# RECOMMENDATION MEETING

6015 15th Ave NW Seattle, WA  
3038032-LU RECOMMENDATION MEETING

The site includes multiple existing structures with surface parking that will be demolished. The proposed development is a 5-story residential building with approximately 51 units and 4 tuck-under parking stalls located off the alley.

RECOMMENDATION MEETING - ENLARGED SITE PLAN - WEST PROPERTY LINE

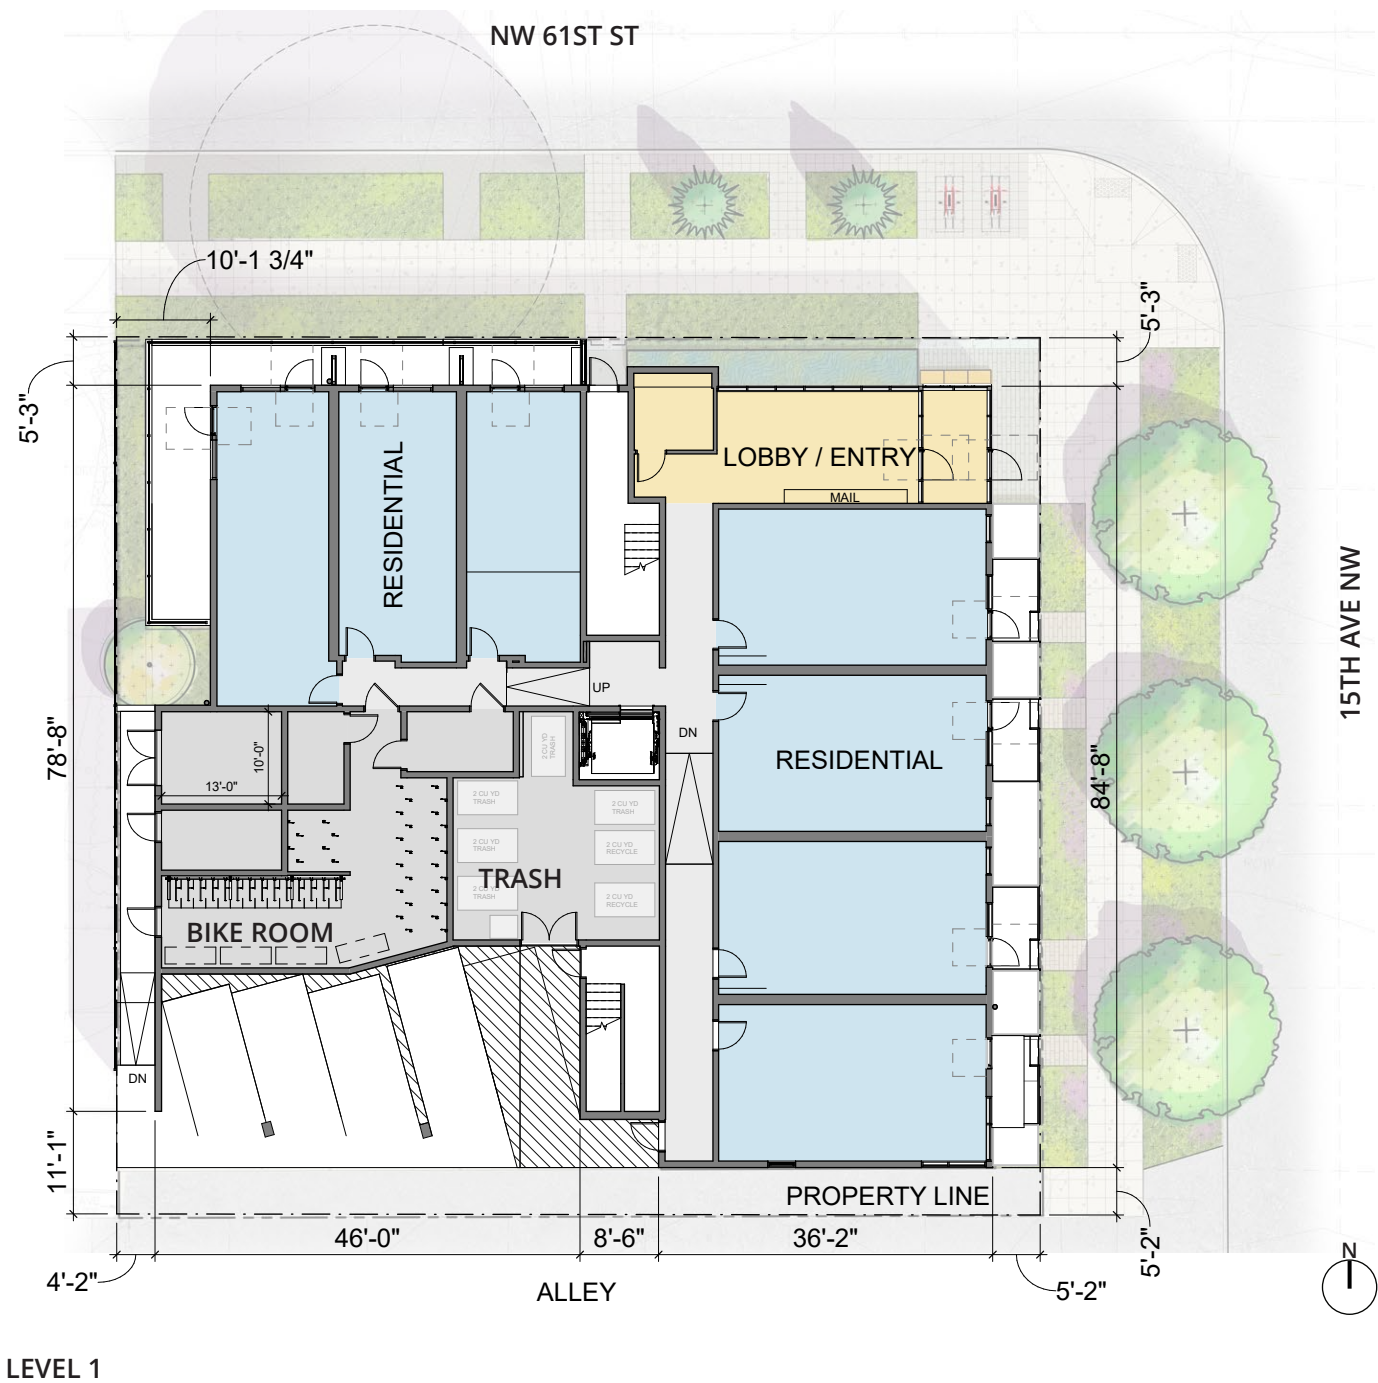
The Board asked the applicant about the uses in the 10 foot rear setback along the west property line. The applicant noted that the ground level units would have direct access to the adjacent exterior space at the north end of the lot. At the south end of the lot, direct access to the bike room and building services would also be provided. The Board appreciated the thoughtful utilization of the space.

The building is setback 10'-1" at the northwest corner of the site that provides a private patio at the ground floor unit and a 3' landscape buffer. A private pathway provides access to the bike parking, building services from the alley. Above level 1 the building is setback 10'-1".
